**COUNTY OF ALBEMARLE
PLANNING STAFF REPORT SUMMARY**

Project Name: ZMA202300004 Cornerstone Community Church	Staff: Rebecca Ragsdale, Planning Manager
Planning Commission Public Hearing: November 14, 2023	Board of Supervisors Public Hearing: To be scheduled
Owner: Peggy W. Dettor/James A. Dettor	Applicant: Line+Grade, Kendra Moon and Daniel Heyer, representing Cornerstone Community Church
Acreage: 3.578 Acres	Rezone from: R1 to C1 Commercial
TMPs: 07800-00-00-058K0	Location: 1395 Stony Point Road
School Districts: Monticello High, Burley Middle, Stone-Robinson Elementary	By-right use: 1 dwelling unit/acre
Magisterial Districts: Rivanna	Proffers: Yes
Proposal: 300-seat religious assembly use and up to 13,500 square feet of commercial uses. The request also includes a special exception (SE202300031) to reduce the 50-foot setback to a residential property line.	Requested # of Dwelling Units: No additional dwelling units are requested.
DA (Development Area) – In Neighborhood 3, in the Pantops Master Plan area.	Comp. Plan Designation: Urban Density Residential – residential (6-34 dwelling units/acre), religious assembly uses, schools and child-care, institutional. Secondary commercial

Image 5 – Sketch of existing versus proposed FEMA floodplain limits

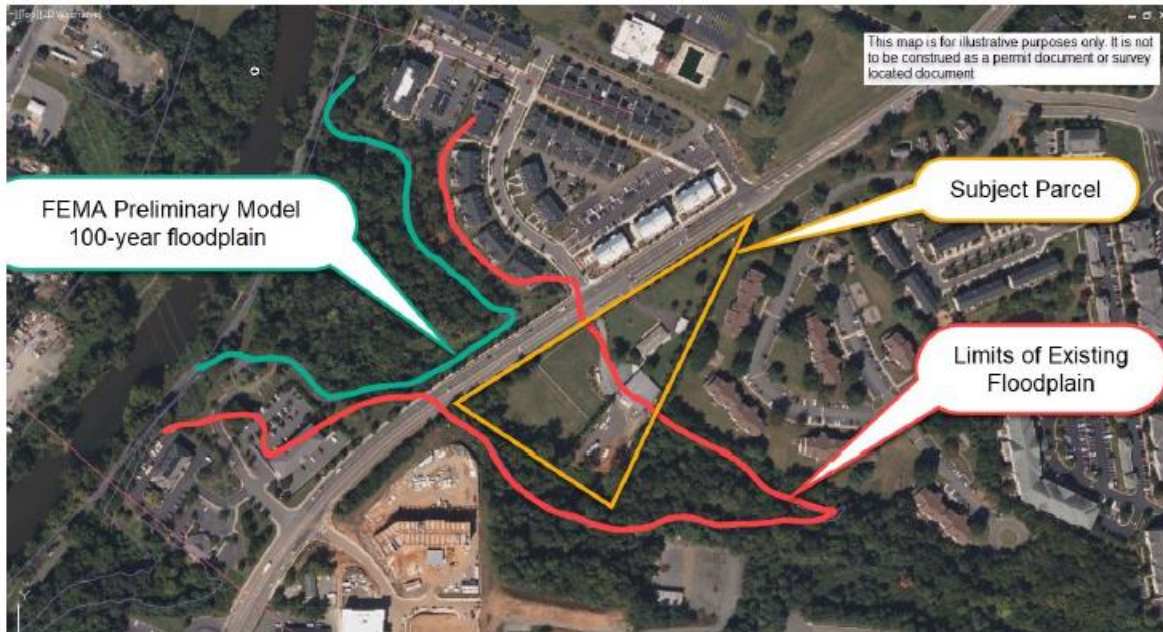
Existing parking and a small portion of the garage building are located within the floodplain according to current FEMA boundaries. The draft FEMA maps available no longer show the property in the floodplain. A required 100-foot stream buffer from the top of the perennial stream bank remains. The applicant’s concept plan has been developed according to FEMA map changes expected in 2024. The concept plan proposes to remove all parking located in the stream buffer and mitigation plantings are proffered. Staff believes this addresses impacts to the stream buffer that have occurred. Should the FEMA maps not be amended as expected, staff does not recommend parking remain in the flood plain even though the ordinance allows parking in the flood plain as long as it is not overnight.
